Bid Bulletin #03

PROJECT: Educare of Winnebago
Bid Package #04
Winnebago, NE

ADDENDUM H

Educare Winnebago
Winnebago, Nebraska
RDG Project No. 2010.175.00, File 35.1

E01.01

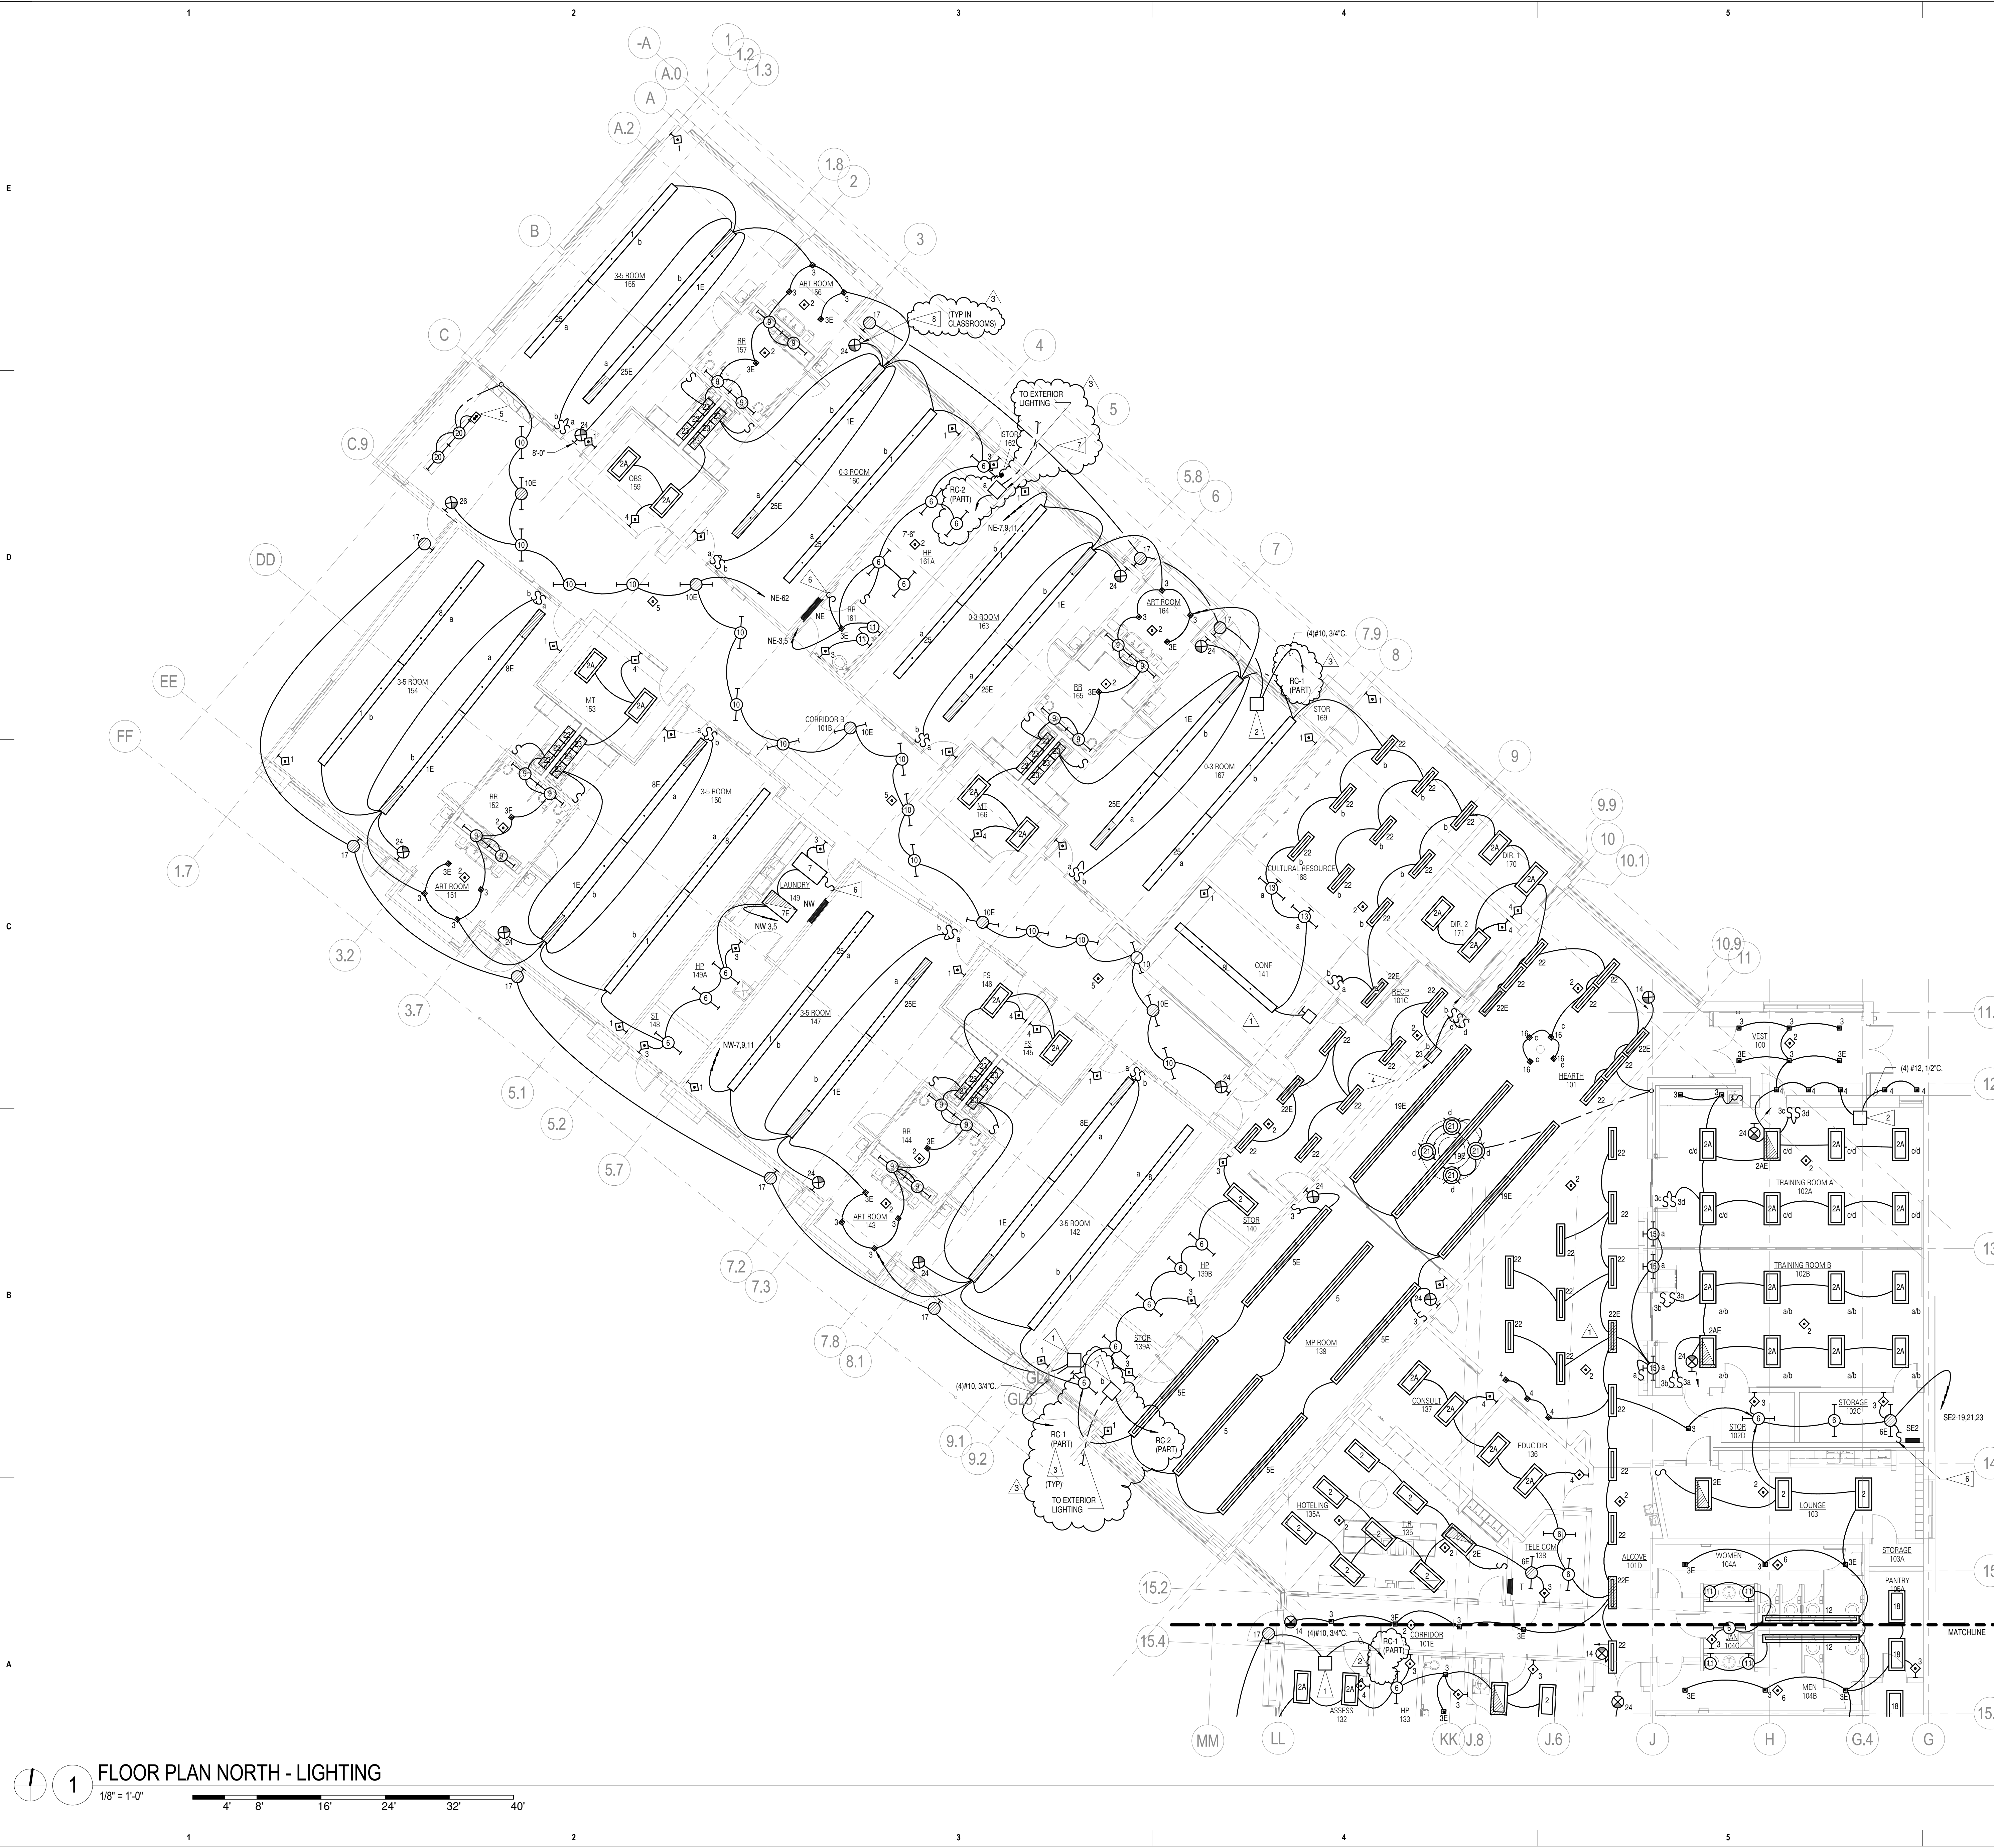
Sheet E01.01 – Floor Plan North-Lighting, Add Alternate 18. Add emergency lighting inverters serving Exterior Site Light Fixture Type D and associated circuiting per attached Sheet E01.01.

- A. Room 139A: Revise circuit for emergency lighting inverter serving Light Fixture Type 17 to **“RC-1 (PART)”** per attached Sketch Sheet E01.01.
- B. Room 160: Remove “Flag Note 5” and apply **“Flag Note 8”** to Light Fixture Type 24 per attached Sketch Sheet E01.01.
- C. Room 167: Revise circuit for emergency lighting inverter serving Light Fixture Type 17 to **“RC-1 (PART)”** per attached Sketch Sheet E01.01.

E01.02

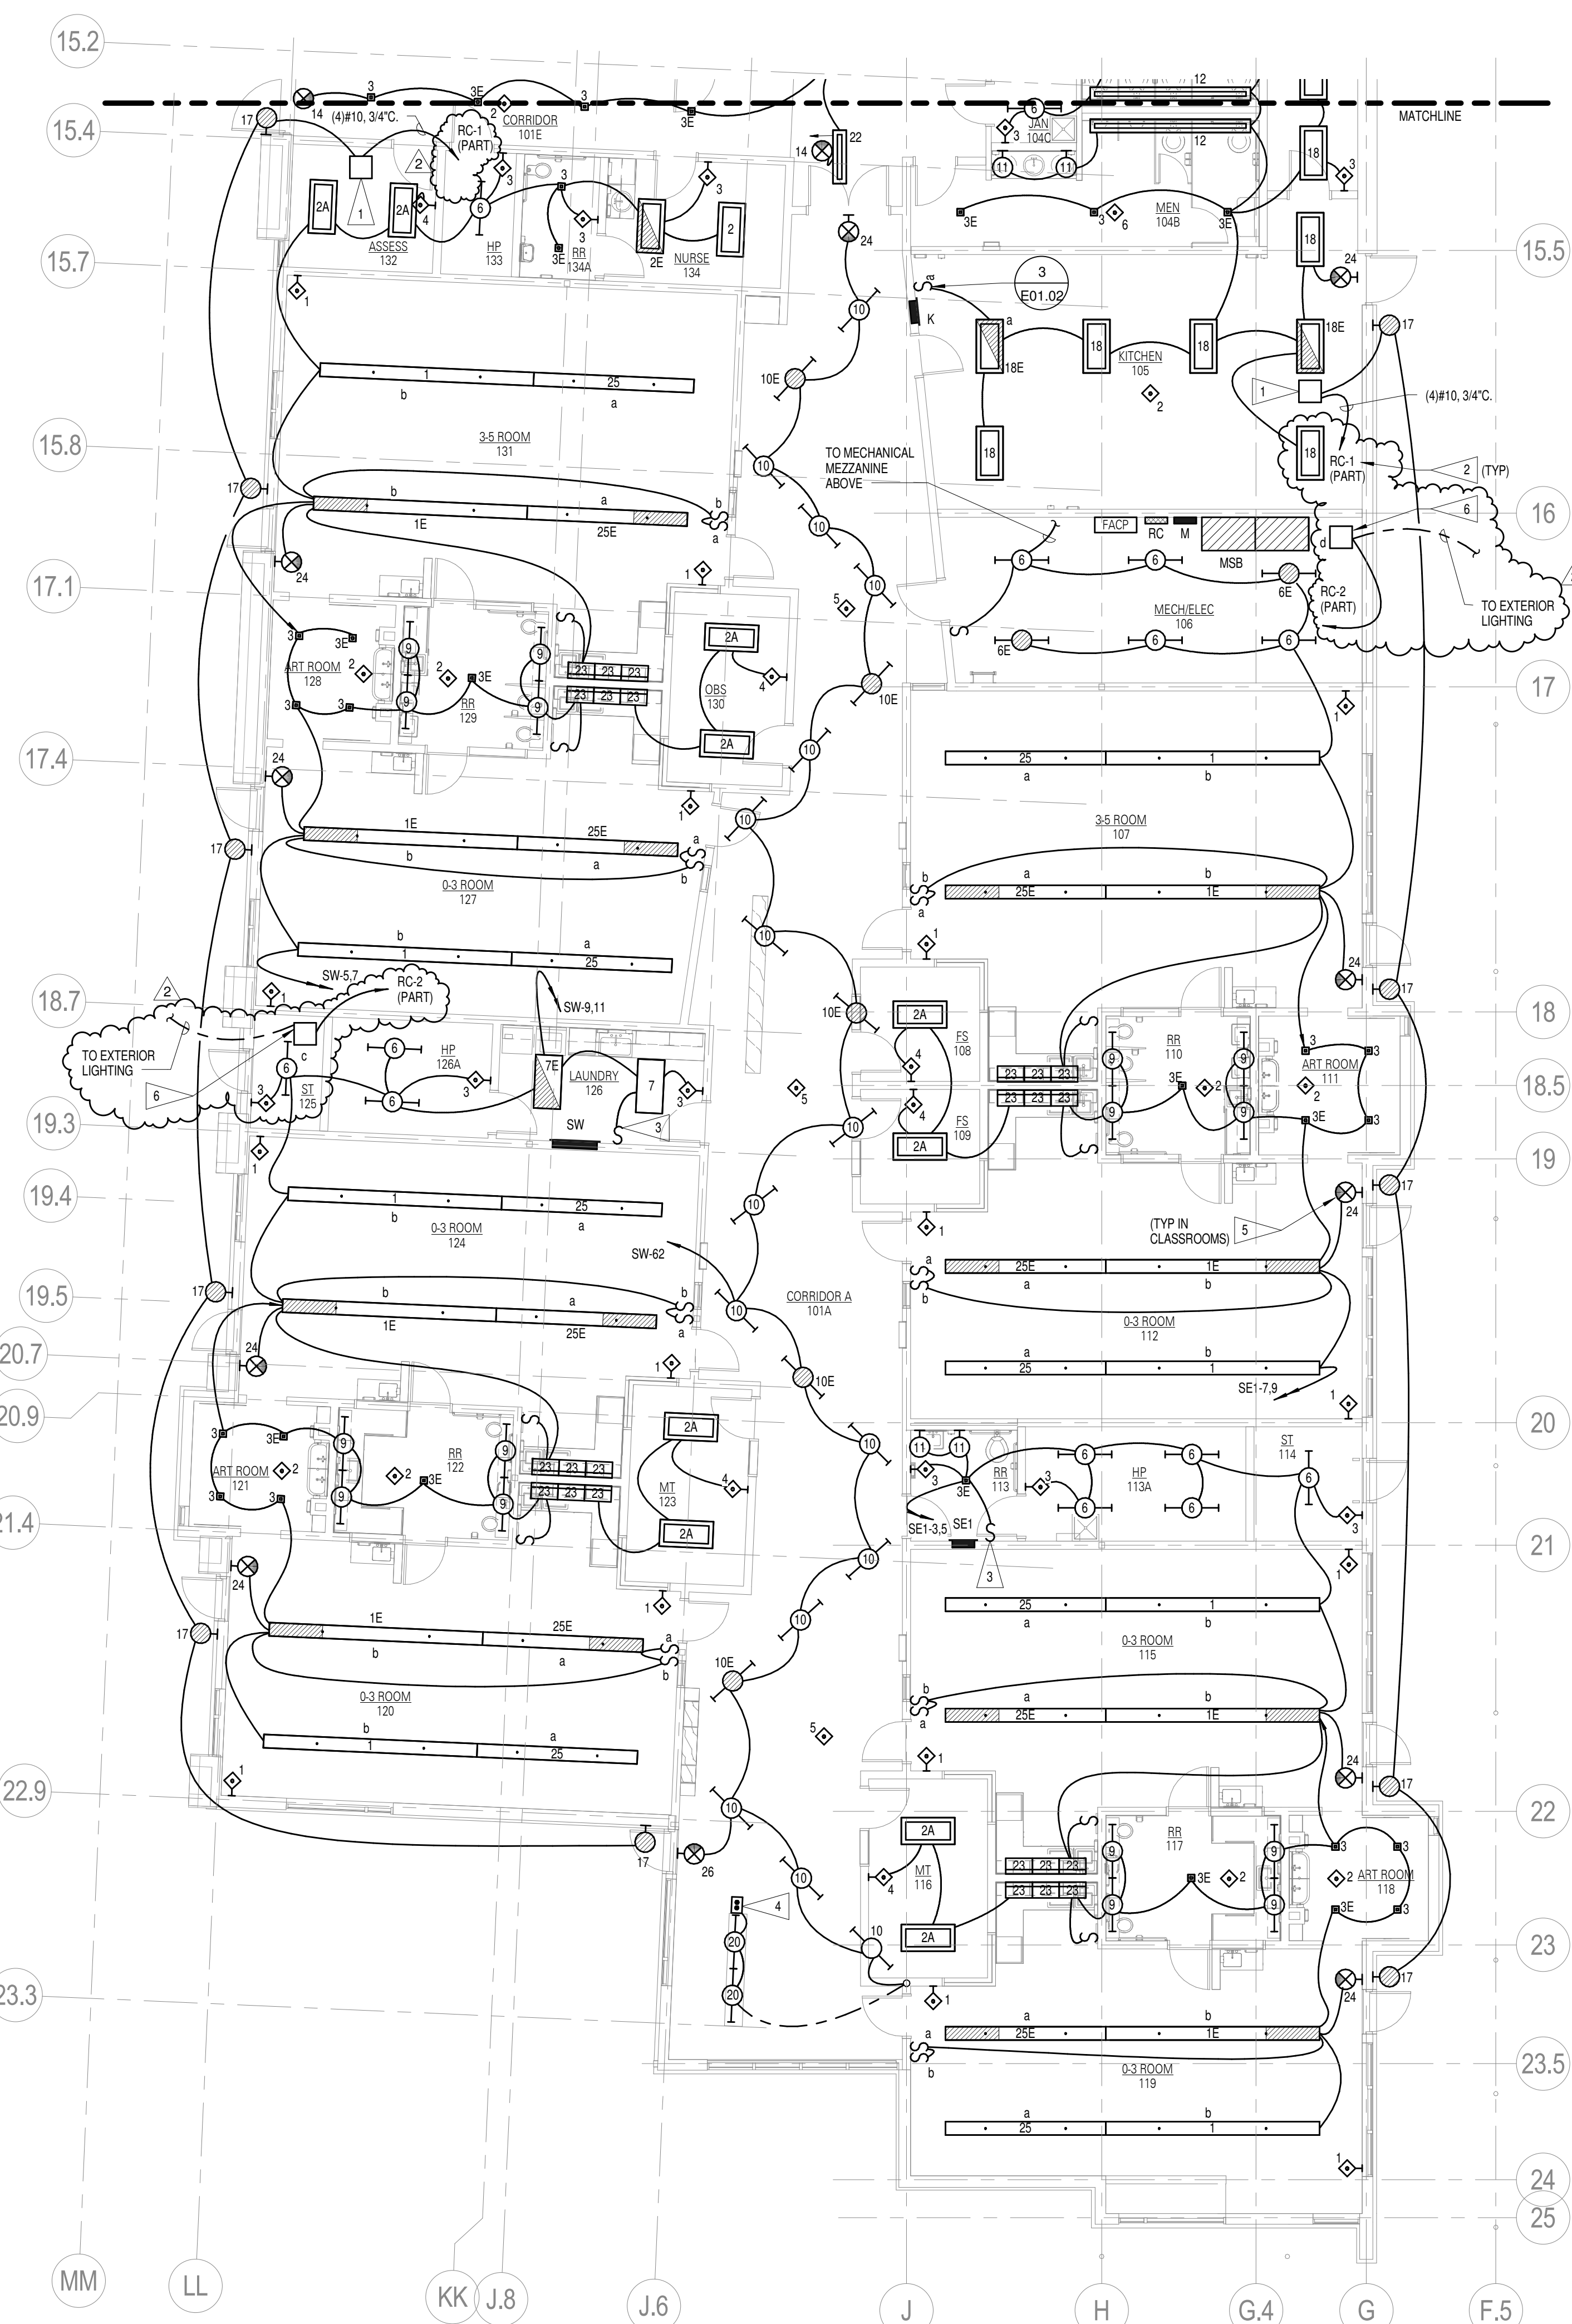
Sheet E01.02 – Floor Plan South-Lighting, Add Alternate 18. Add emergency lighting inverters serving Exterior Site Light Fixture Type D and associated circuiting per attached Sheet E01.02.

- A. Room 105: Revise circuit for emergency lighting inverter serving Light Fixture Type 17 to **“RC-1 (PART)”** per attached Sketch Sheet E01.02.
- B. Room 132: Revise circuit for emergency lighting inverter serving Light Fixture Type 17 to **“RC-1 (PART)”** per attached Sketch Sheet E01.02.
